**Re: Endangered Species Act, Section 7 Consultation:  
U.S. Nuclear Regulatory Commission, Pilgrim Nuclear Power Station,  
Plymouth, Massachusetts: Relicensing**

RE: MCZM review of the Entergy-Pilgrim Station § 316 Demonstration Report.

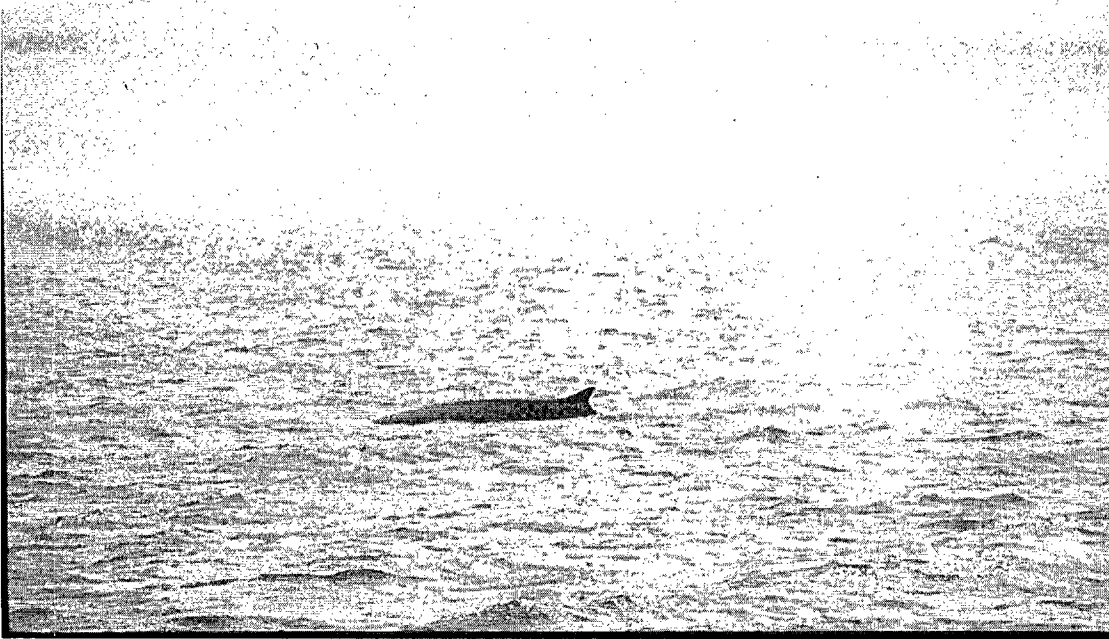
**Second**, the biological assessment ignores scientific data readily available **about whale activity in the area**. For example, a quick review of available data produced this photo of a federally endangered fin whale (*balaenopter physalus*) in front of PNPS. The NRC's biological assessment contains a scant half page of "assessment" of the impacts of PNPS on the fin whale. NUREG-1437, p. E-71.
